FORM APPROVED
OMB NO. 1004-0135
Expires: July 31, 2010**SUNDRY NOTICES AND REPORTS ON WELLS**
*Do not use this form for proposals to drill or to re-enter an abandoned well. Use form 3160-3 (APD) for such proposals.***SUBMIT IN TRIPLICATE - Other instructions on reverse side.**

CHEVRON U.S.A. INC. RESPECTFULLY REQUESTS APPROVAL TO RECOMPLETE THE SUBJECT WELL FROM THE QUAIL RIDGE; MORROW (GAS) FIELD & POOL TO THE LEA; DELAWARE, NORTHEAST FIELD AND POOL.

Codorniz 28 Federal 3
30-025-37523
Chevron USA Incorporated
Conditions of Approval

PROPOSED

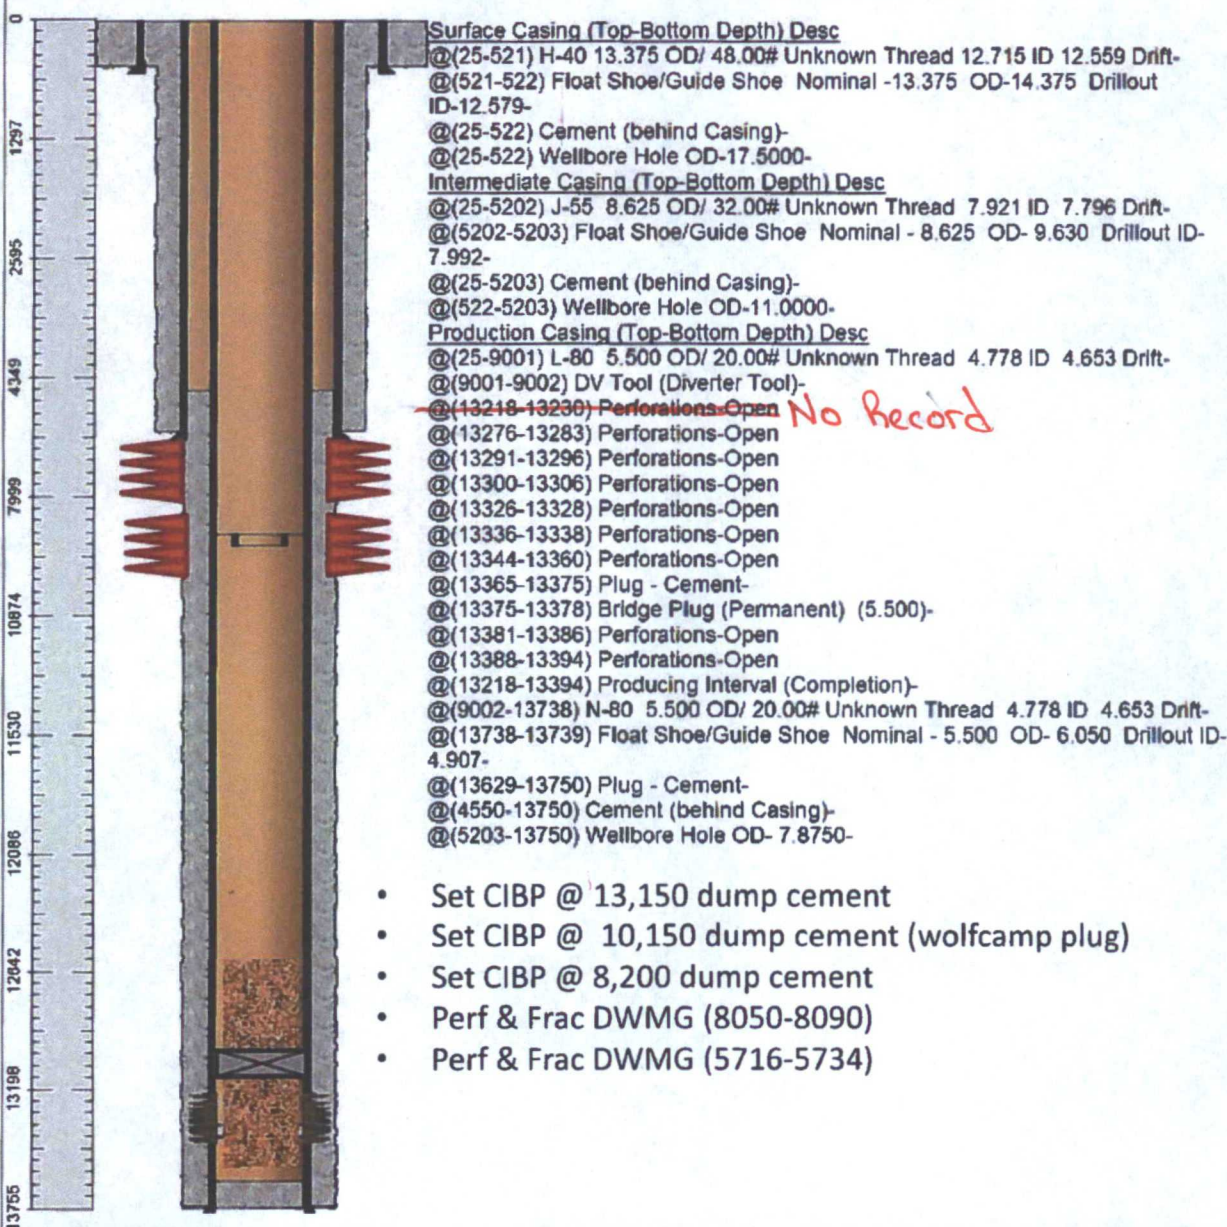
1. Operator shall set a CIBP at 13,176 feet, and set Class H cement as a cap. This will isolate the perforations in the Morrow. Tag at 13,126 feet is required which shall be witnessed by BLM. No perforations were recorded at 13,218 feet through 13,230 feet.

2. Operator shall set a CIBP at 12,782 feet, and set Class H cement as a cap. This will isolate the top of Morrow. Tag at 12,732 feet is required.
3. Operator shall set a CIBP at 12,144 feet, and set Class H cement as a cap. This will isolate the top of Strawn, as well as the low pressure zone that is commonly above. Tag at 12,094 feet is required.

4. Operator shall set a CIBP at 10,942 feet, and set Class H cement as a cap. This will isolate the top of Wolfcamp. Tag at 10,892 feet is required.
5. Operator shall set a CIBP at 8201 feet, and set Class H cement as a cap. This will isolate the top of Bone Springs. Tag at 8151 feet is required.

7. Operator approved to perforate and then fracture the intervals of 8090 feet through 8050 feet and 5734 feet through 5716 feet.
8. Before casing or a liner is added or replaced, prior BLM approval of the design is required. Use notice of intent Form 3160-5.
